**ADDENDUM TO THE CONTRACT**  
**for the**  
**PORTAGE COVE HARBOR EXPANSION**

**ADDENDUM NO.: TWO**

**DATE ADDENDUM ISSUED:** September 29, 2016

SHEET TITLE:  
**BARRIER PILES AND WALERS**

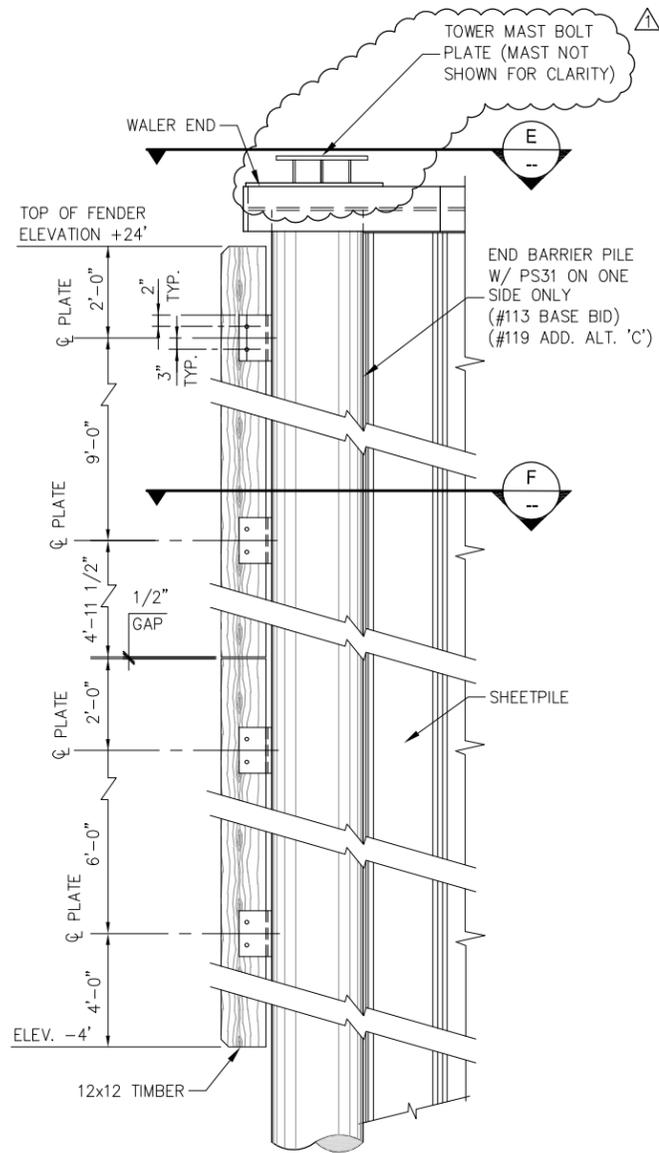
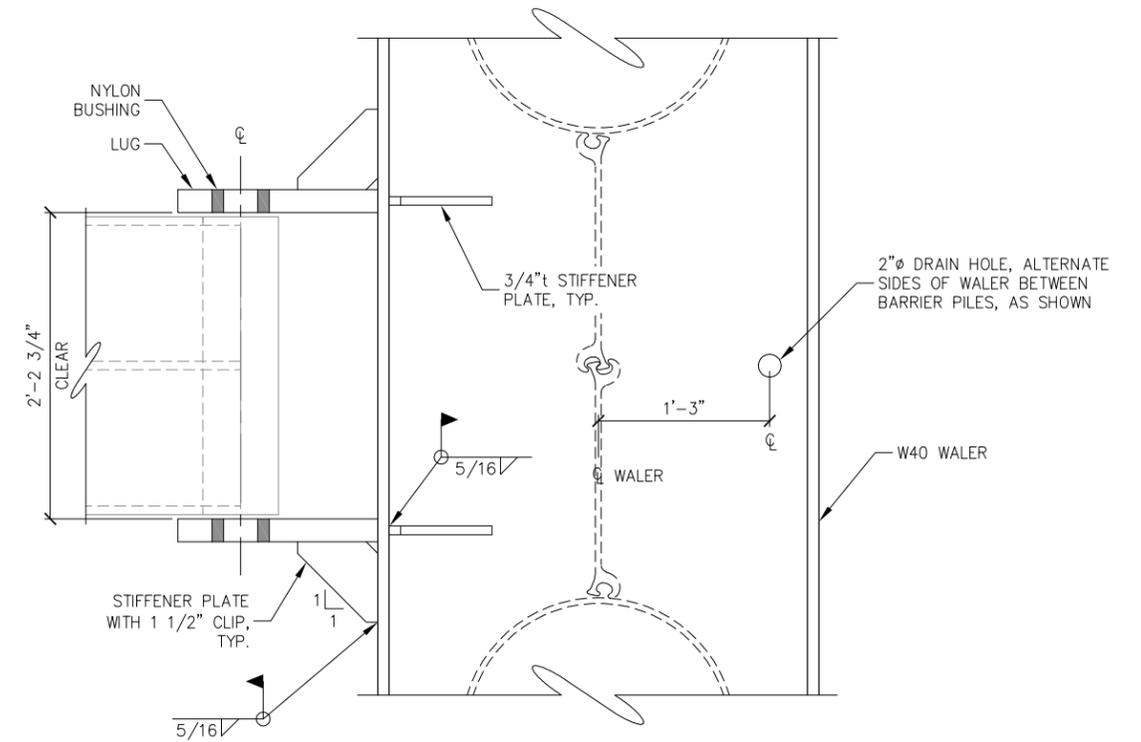
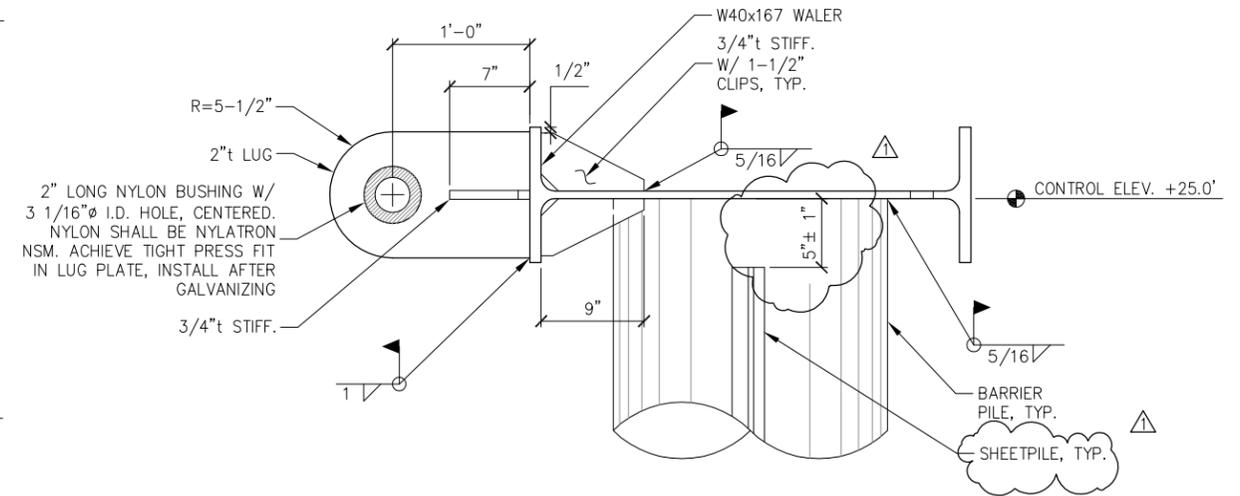
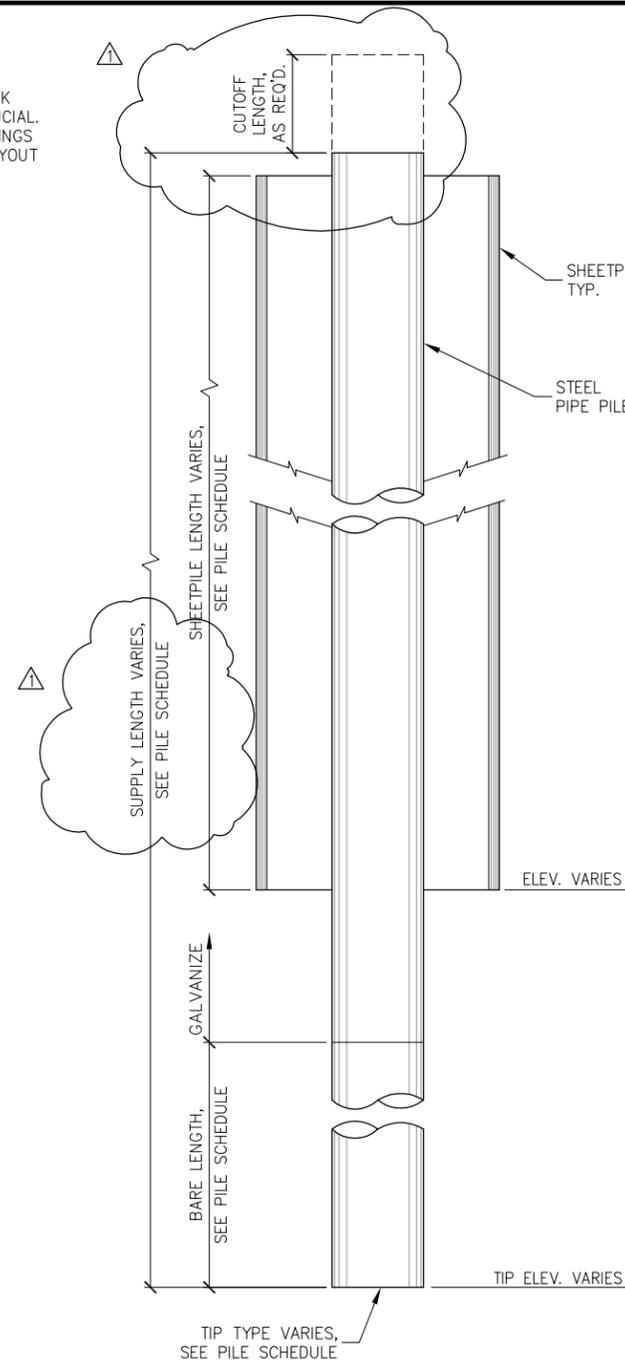
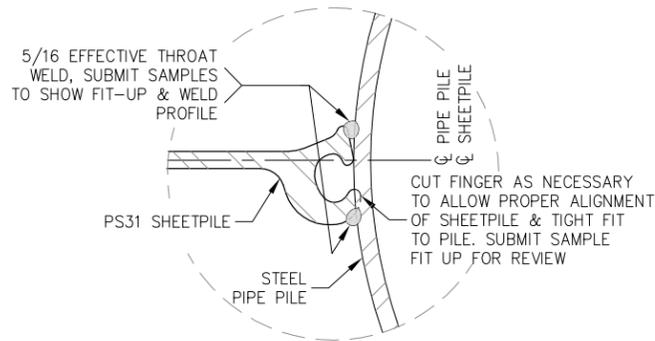
- Item No. 29** DRAWING SHEET 5.09 BARRIER PILES AND WALERS: *Replace* drawing in its entirety with the attached drawing similarly titled, labeled Addendum No. 2 and dated 9/21/16.

REVISIONS					
REV.	DATE	DESCRIPTION	DWN.	CKD.	APP.
△	9/21/16	ADDENDUM NO.2	GRD	JDO	CRS

SHEET TITLE: **FENDER AND NAVIGATION TOWER MOUNT**

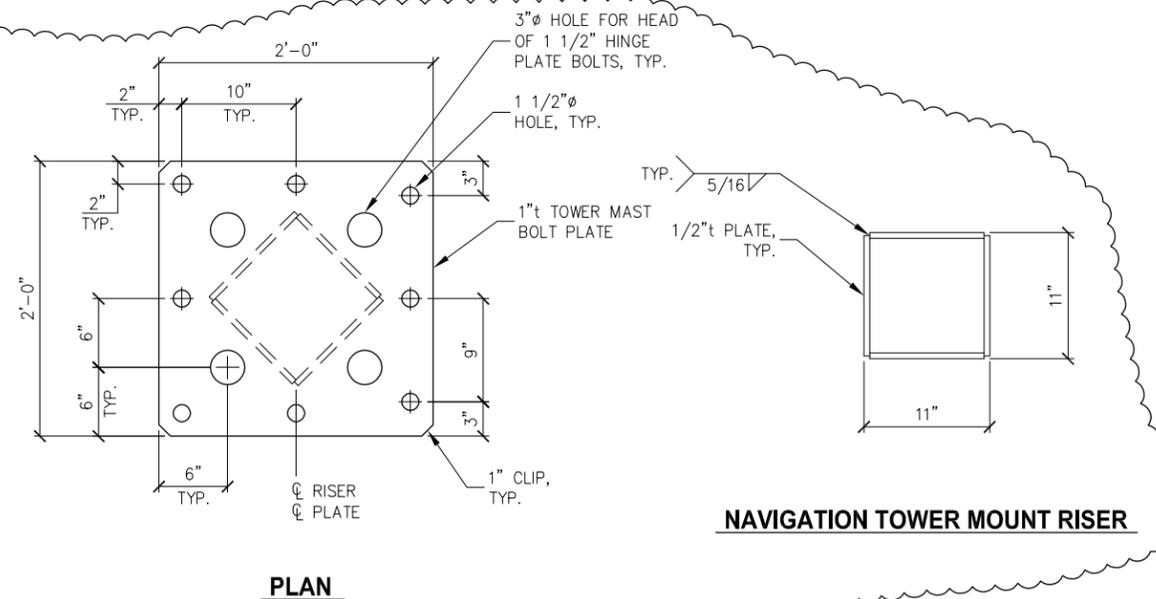
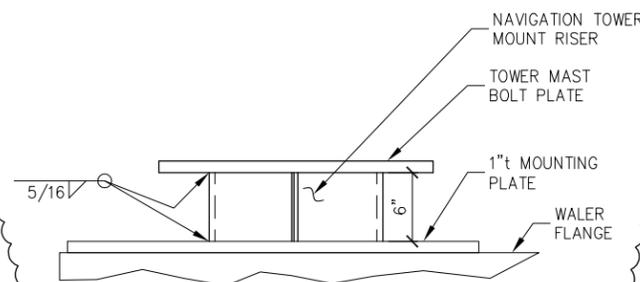
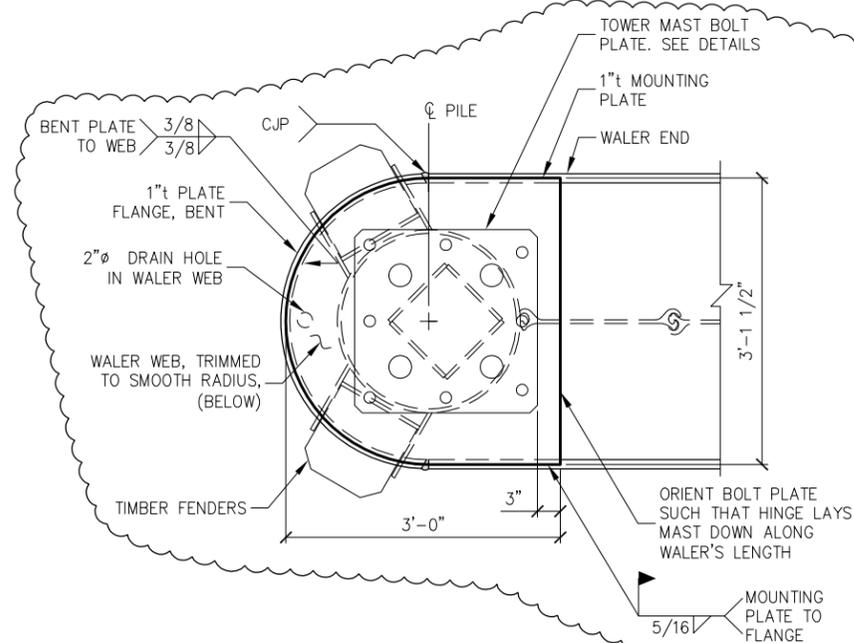
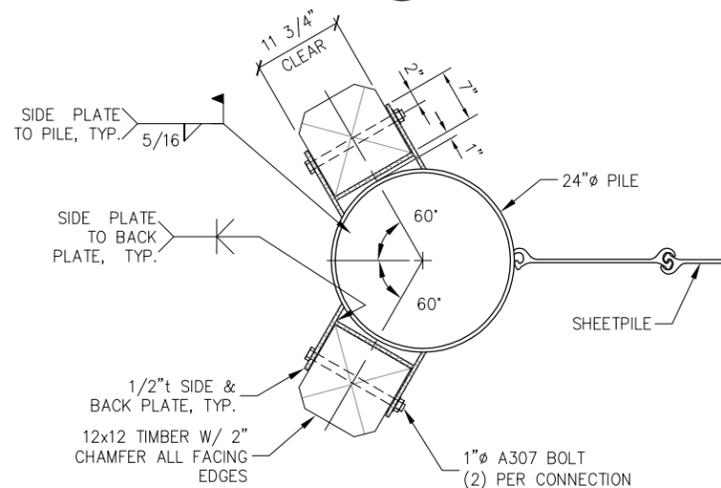
- Item No. 30** DRAWING SHEET 5.12 FENDER AND MARINE SIGNAL LIGHT: *Replace* drawing in its entirety with the attached drawing titled FENDER AND NAVIGATION TOWER MOUNT, labeled Addendum No. 2 and dated 9/21/16.

REVISIONS					
REV.	DATE	DESCRIPTION	DWN.	CKD.	APP.
△	9/21/16	ADDENDUM NO.2: NAVIGATION TOWER MOUNT	GRD	JDO	CRS
